GARY R. PETERSON
Vice President
McGuire Nuclear Station

SUBJECT: Duke Energy Corporation (Duke)
McGuire Nuclear Station Units 1 and 2
Docket Nos. 50-369 / 50-370
Proposed Technical Specification (TS) Amendments
TS 3.7.15 - Spent Fuel Assembly Storage, and TS 4.3 -
Fuel Storage

Attachment 1 provides marked up pages of the existing McGuire TSs showing the proposed changes. Attachment 2 contains the new McGuire TS pages. The Description of Proposed Changes and Technical Justification is provided in Attachment 3. Pursuant to 10 CFR 50.92, Attachment 4 documents the determination that this proposed amendment contains no significant hazards considerations. Pursuant to 10 CFR 51.22 (c)(9), Attachment 5 provides the basis for the categorical exclusion from performing an Environmental Assessment or Impact Statement. A summary of the McGuire Spent Fuel Pool Criticality Analysis is shown in Attachment 6. Attachments 7 and 8 show the proposed and revised BASES for TS 3.7.14 and 3.7.15.

Figure 3.7.15-1 (page 1 of 1)
Required 3 out of 4 Loading Pattern for Restricted Region 1A Storage

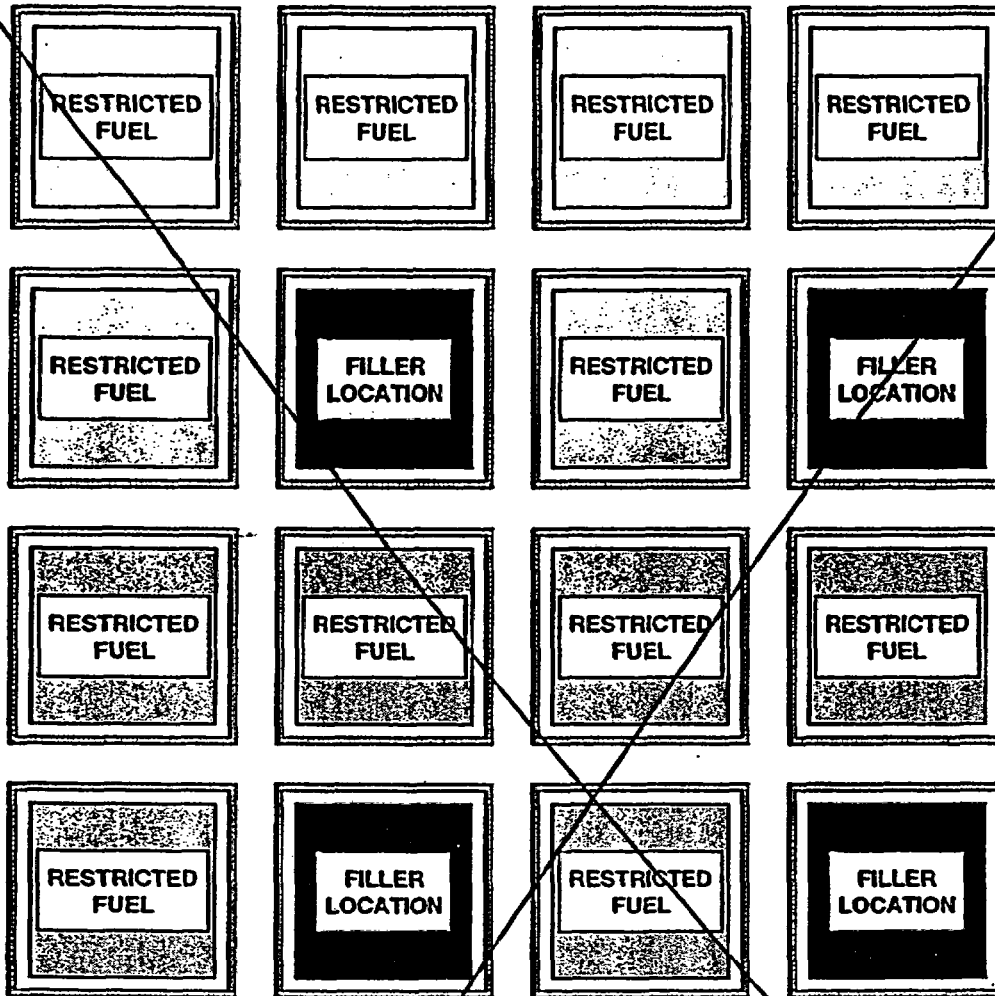
Delete all existing Figures 3.7.15-1 through 3.7.15-7 and replace with new Figures 3.7.15-1 through 3.7.15-2 (see Attachment 2)

Delete this Figure

- l) New Figure 3.7.15-1:** This TS Figure illustrates the loading pattern to be employed in the Region 2 spent fuel storage racks for the 2 out of 4 restricted/filler storage configuration. There are no boundary conditions specified for this storage configuration. The loading pattern illustrated by this figure is based on the criticality analysis discussed in Attachment 6. The analysis no longer takes credit for any remaining Boraflex in the Region 2 spent fuel storage racks. For each fuel assembly design type, credit is taken for burnup, cooling time and partial credit for the soluble boron in the spent fuel pool water.

Figure 3.7.15-2 (page 1 of 1)
Required 2 out of 4 Loading Pattern for Restricted Region 1B Storage

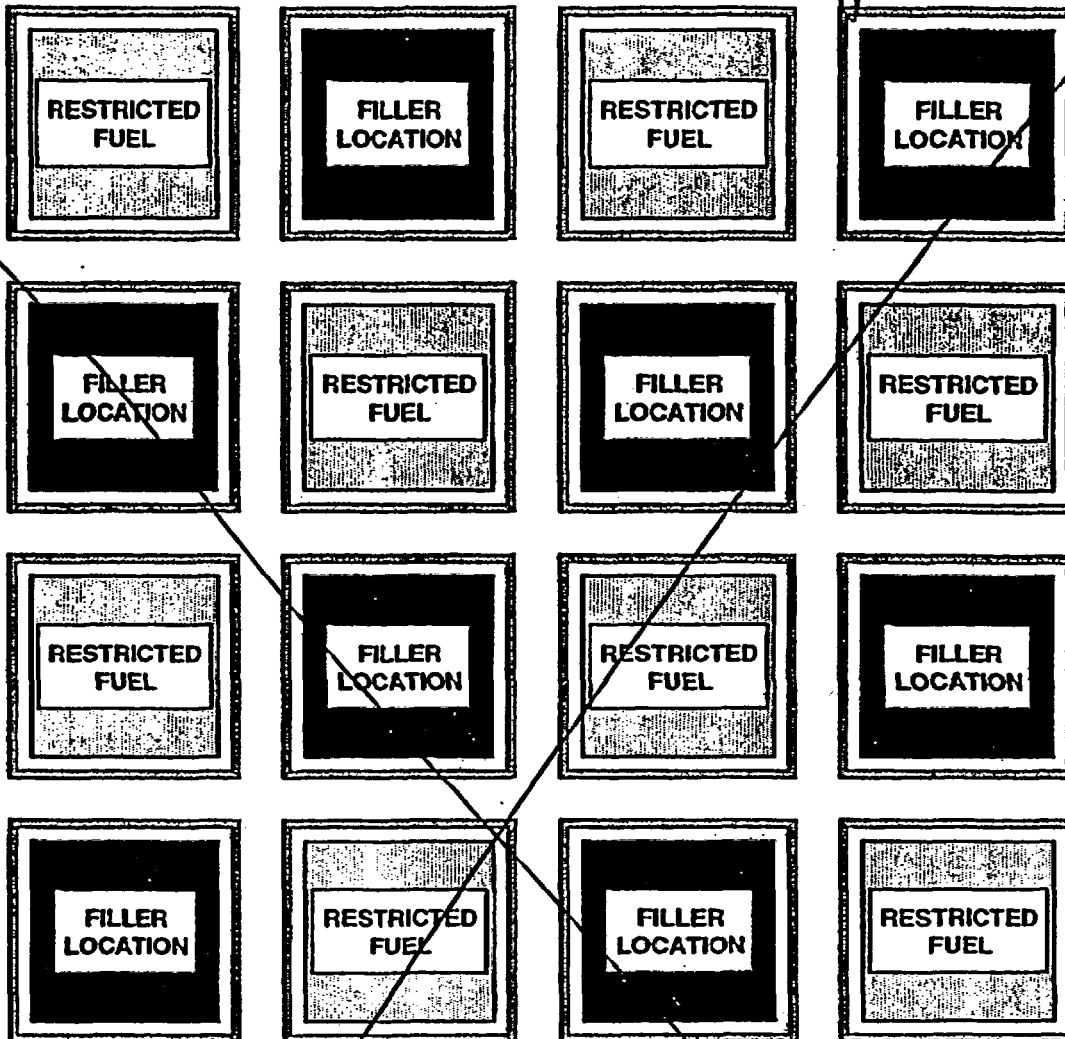
~~Set~~ Delete This Figure

Figure 3.7.15-3 (page 1 of 1)
Required 2 out of 4 Loading Pattern for Checkerboard Region 1B Storage

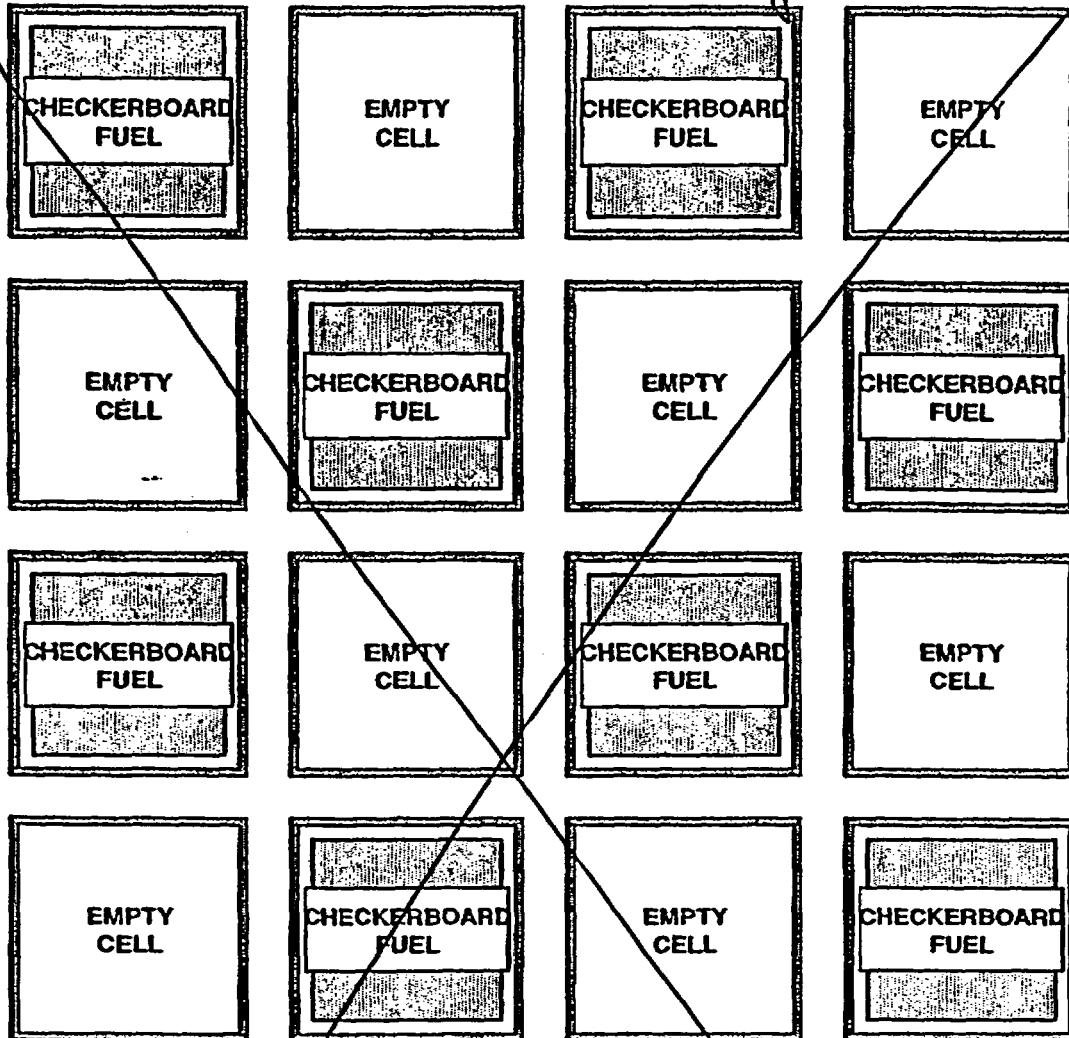
Delete this Figure

Figure 3.7.15-4 (page 1 of 1)
Required 2 out of 4 Loading Pattern for Restricted Region 2A Storage

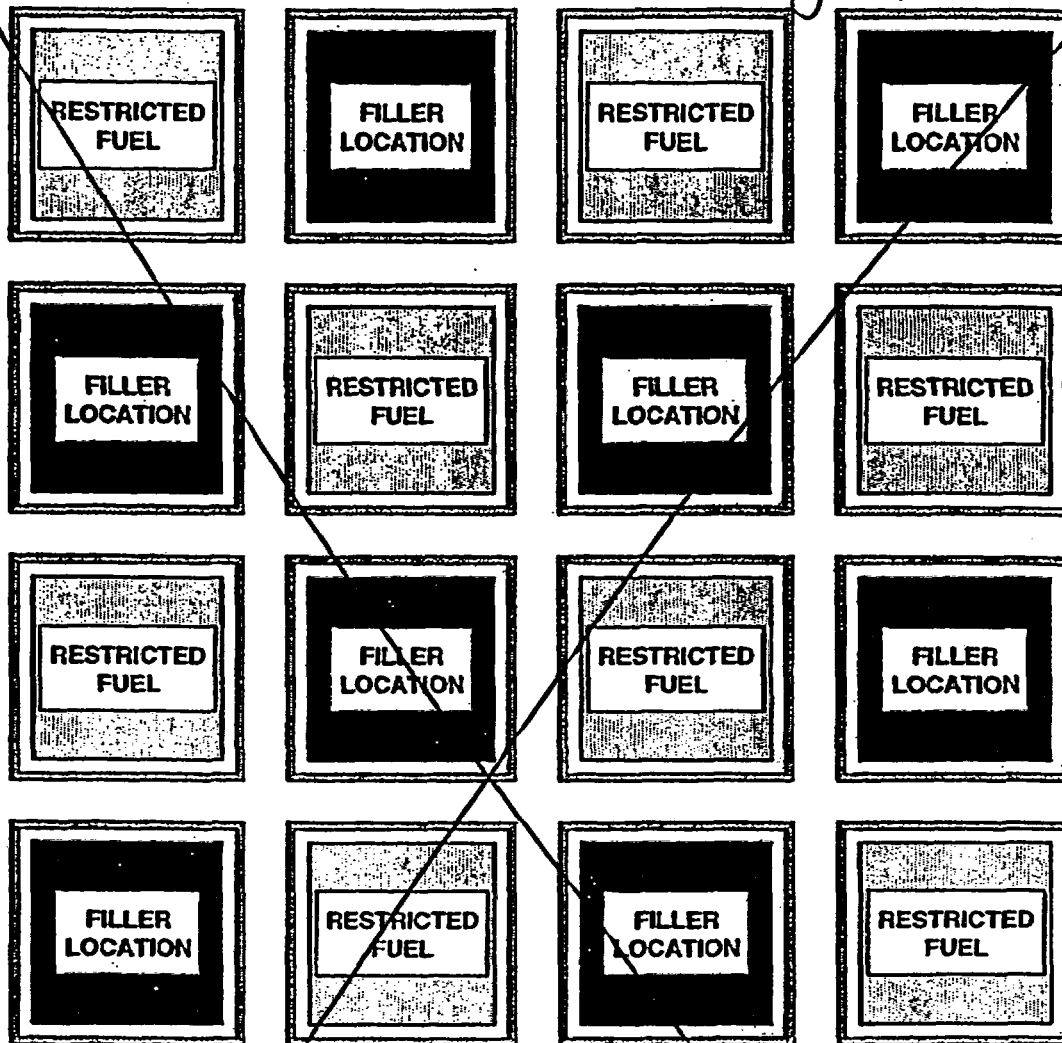
Delete This Figure

Figure 3.7.15-5 (page 1 of 1)
Required 2 out of 4 Loading Pattern for Checkerboard Region 2A Storage

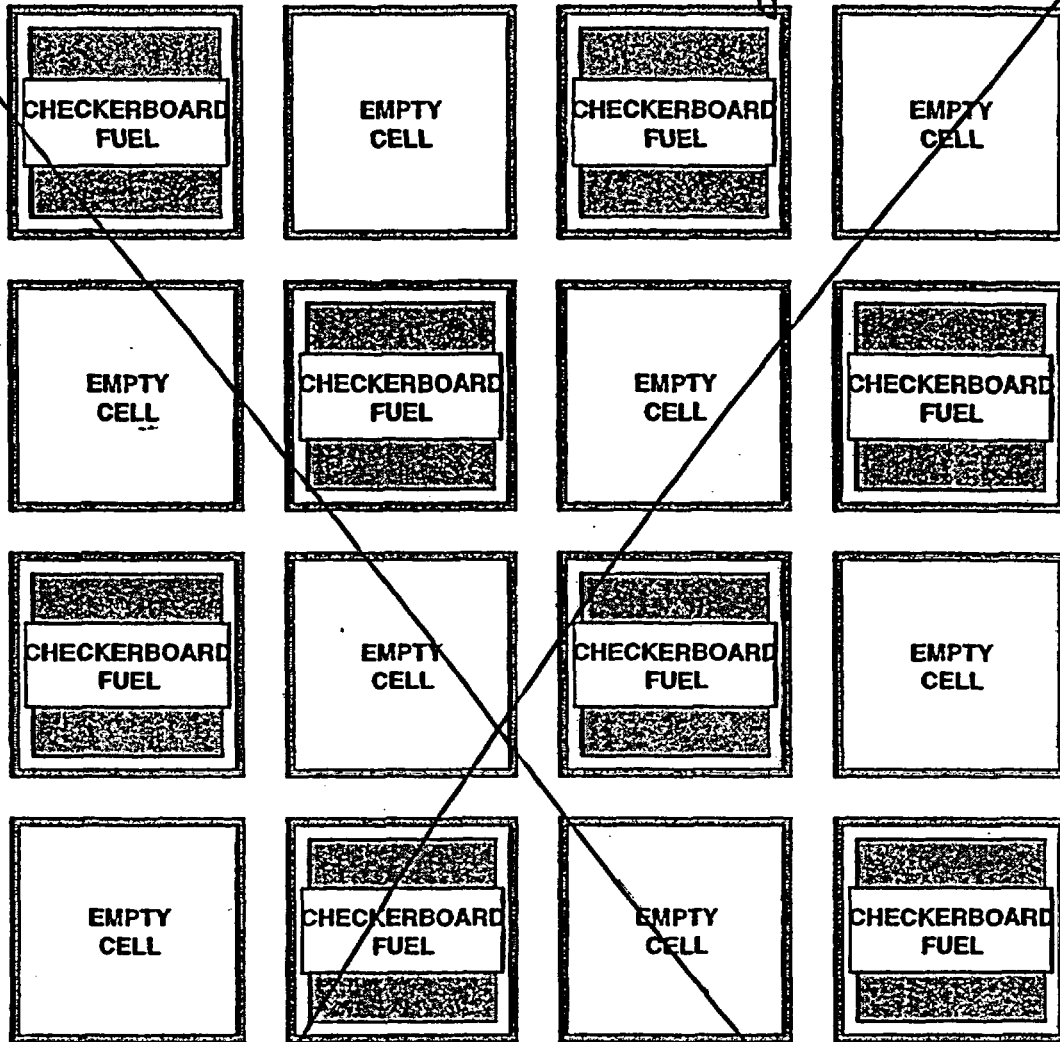
Delete this Figure

Figure 3.7.15-6 (page 1 of 1)
Required 1 out of 4 Loading Pattern for Restricted Region 2B Storage

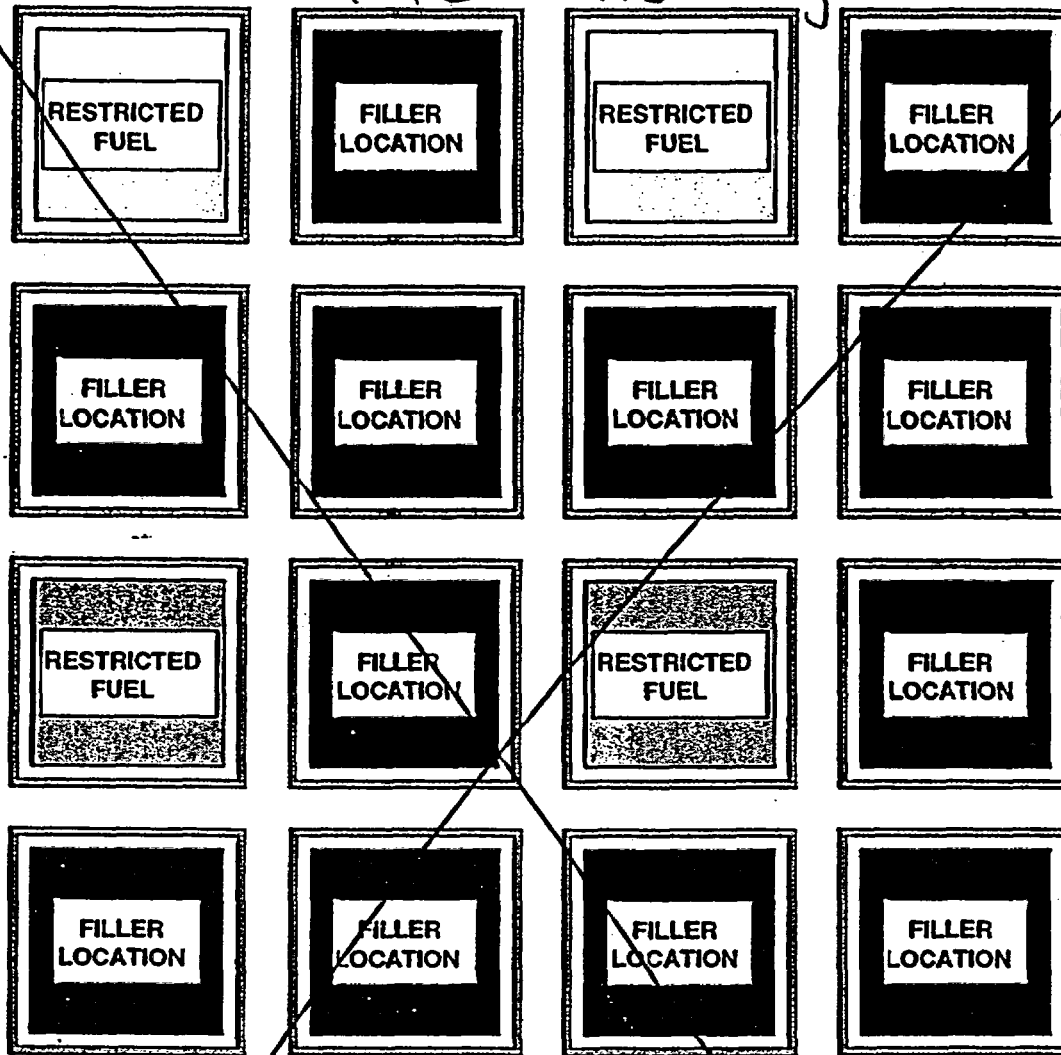
Delete This Figure

Figure 3.7.15-7 (page 1 of 1)
Required 1 out of 4 Loading Pattern for Checkerboard Region 2B Storage

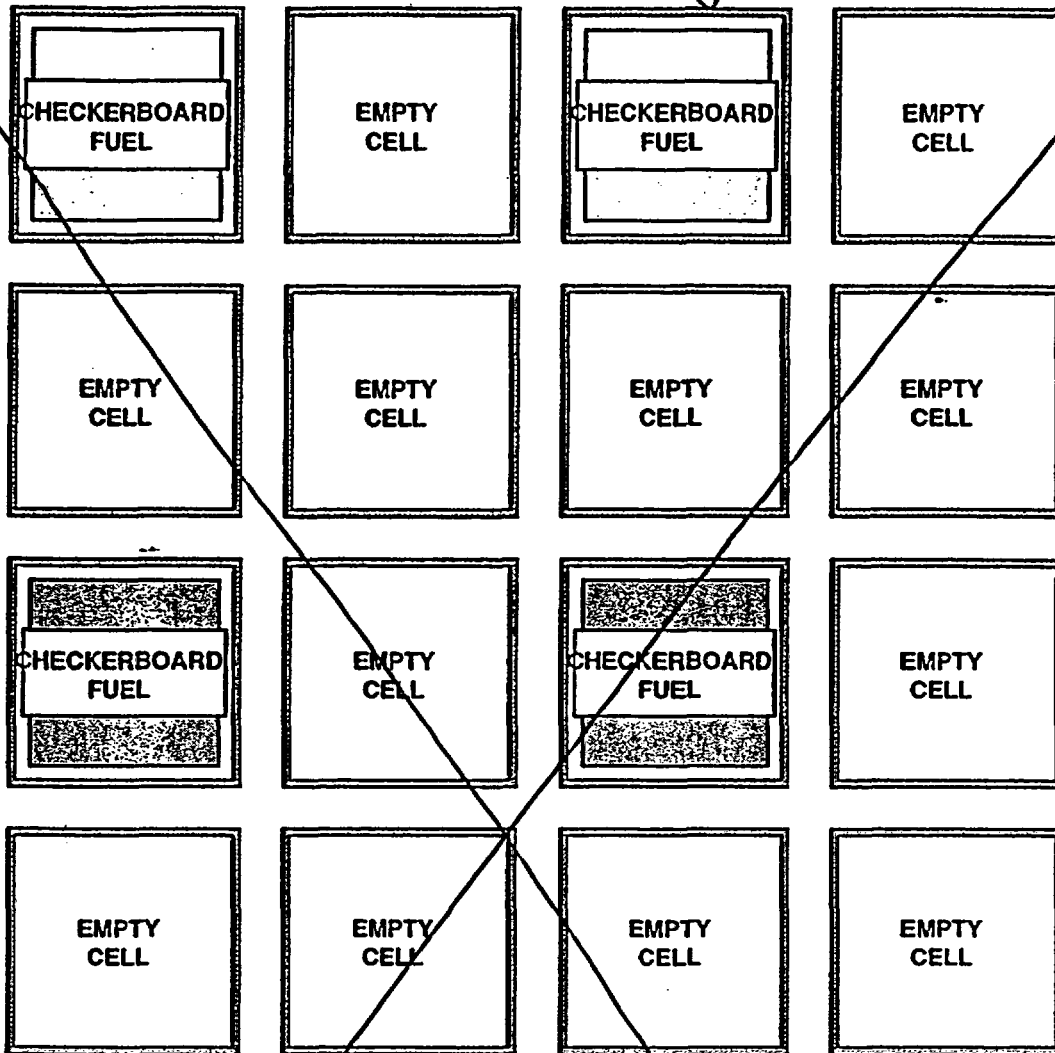
Delete This Figure

Figure 3.7.15-2 (page 1 of 1)
Required 3 out of 4 Loading Pattern for Checkerboard Region 2 Storage

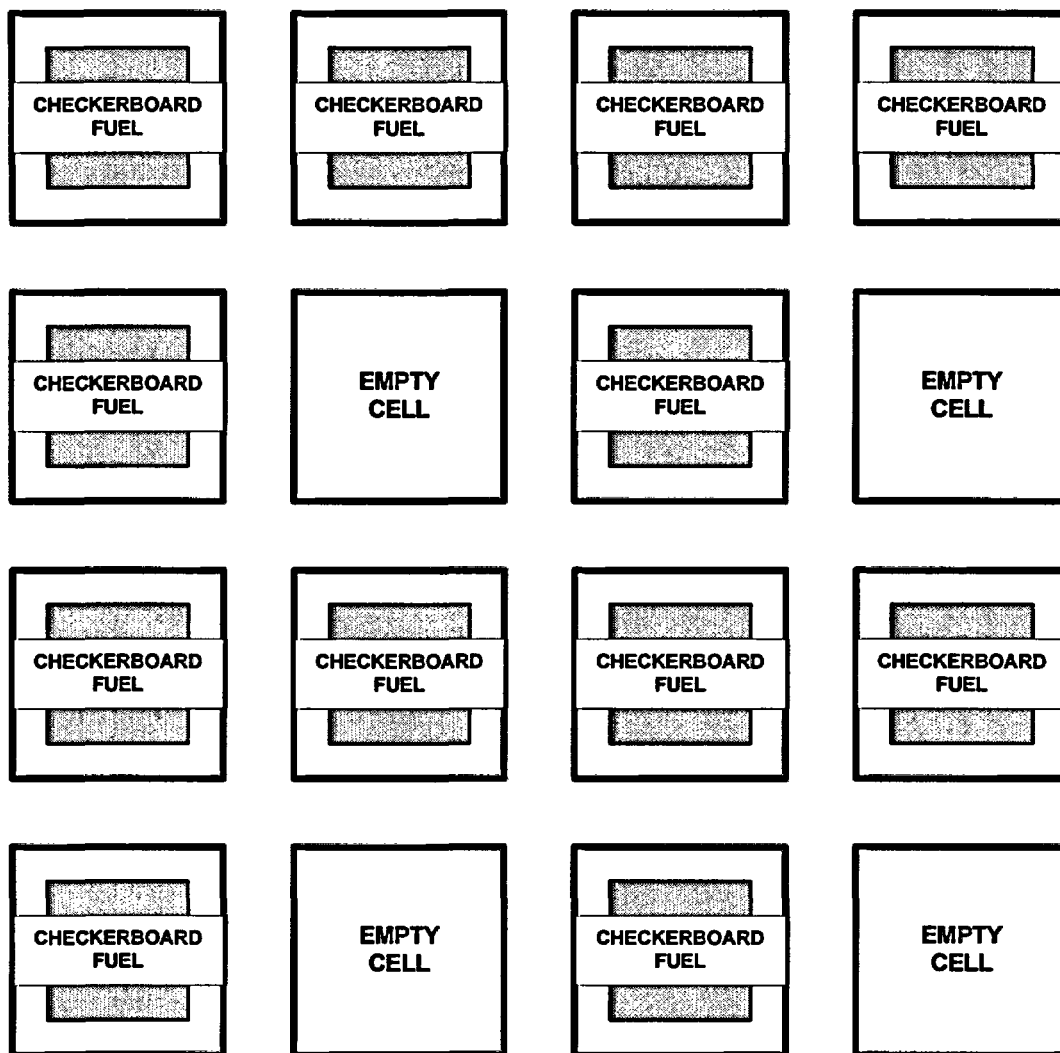
- m) New Figure 3.7.15-2:** This TS Figure illustrates the loading pattern to be employed in the Region 2 spent fuel storage racks for the 3 out of 4 checkerboard/empty cell storage configuration. Boundary conditions for this storage configuration are specified. For this configuration, a string of checkerboard fuel is to be bounded by either; 1) an alternating pattern of checkerboard fuel and empty cell, 2) string of empty cells, or 3) spent fuel pool wall. The loading pattern illustrated by this figure is based on the criticality analysis discussed in Attachment 6. The analysis no longer takes credit for any remaining Boraflex in the Region 2 spent fuel storage racks. For each fuel assembly design type, credit is taken for burnup, cooling time and partial credit for the soluble boron in the spent fuel pool water.
